TECHNICAL INFORMATION

64640

- Subject** ▶ Change of Cushion and Pan Head Screw
- For Models** ▶ 410
- Country** ▶ All countries
- Description** ▶ Cushion and Pan Head Screw have been changed as shown below.

<Cross section of Cushion and Pan Head Screw>

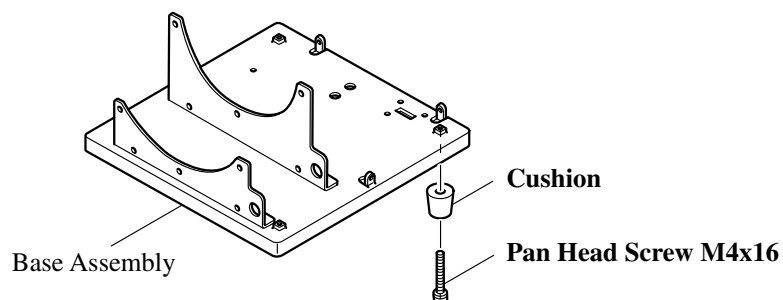
► Current	► New
<p>Ø 8.0 mm (5/16")</p> <p>Cushion</p> <p>Adhesive (Neji Lock Super TB 1303B)</p> <p>Pan Head Screw M4x16</p>	<p>Ø 10.5 mm (13/32")</p> <p>Cushion</p> <p>No adhesive</p> <p>+ Pan Head Screw M4</p>

Item No.	Current part		Q'ty	I/C	New part		Q'ty	Note
057	Cushion 421304-1		4	No	Cushion 421826-1		4	Interchangeable as a set
056	Pan Head Screw M4x16 911128-8		4	No	+ Pan Head Screw M4 265094-4		4	
—	Neji Lock Super TB 1303B 045004-5A		0.1g
